# UNITED STATES PATENT AND TRADEMARK OFFICE

10/089,041

<b>Office Action Summary</b>	<b>Application No.</b> 10/089,041	<b>Applicant(s)</b> GRIMM ET AL.	
	<b>Examiner</b> Jerry Redman	<b>Art Unit</b> 3634

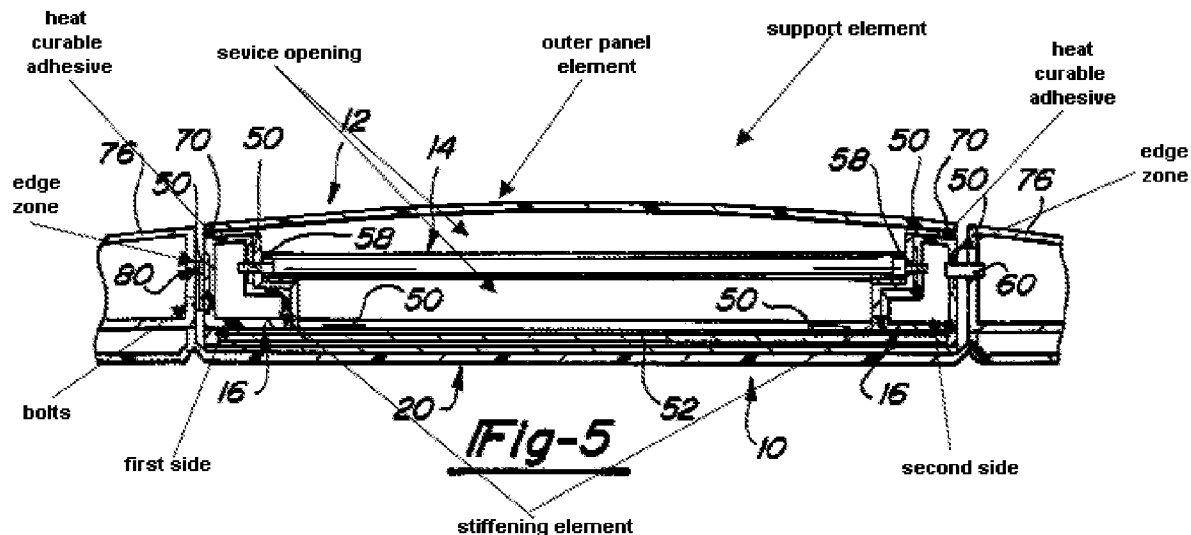
As best understood, claims 13-18, 20-30 and 34-35, 38-41 are further rejected under 35 U.S.C. 102(b) as being anticipated by Ritchie (5,857,732). Ritchie (5,857,732) discloses a vehicle door module comprising a support element (see figure below), an outer panel element (12) to close the service opening along an edge zone, an elongated

metal stiffening element (50), a spacing element (70) in the form of a heat curable adhesive (column 4, lines 34-67) which allows adjustability between the parts (i.e., the outer panel element and the elongated stiffening element) in two dimensions, which are to be fastened, and bolts (80) detachably joined to the stiffening element (50) and support element, an interior panel element (20), and a hinge (80).
